Project Assessment Review of the Draft Report

Review of the Project Group:
Group Code: AP1000 51
Full title: AP 1000

SH2702 - Nuclear Reactor Technology
Master programme in Nuclear Energy Engineering

AP 1000

Figure 13: Axial pressure drop in average and hot channel.

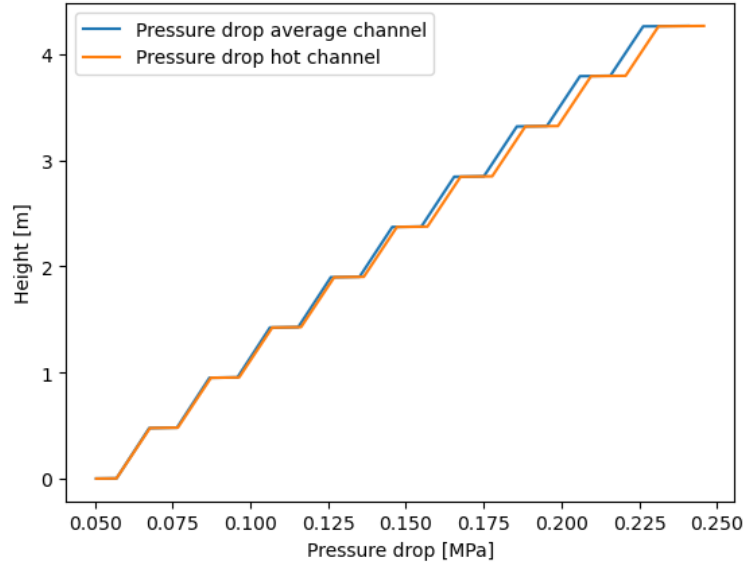
5. <i>Calculate CHF margins in a hot channel</i> (Task 5, ILO4a)	3	A brief explanation of CHF and DNBR. Shouldn’t the height be the abscissa/x-axis in Fig. 13?
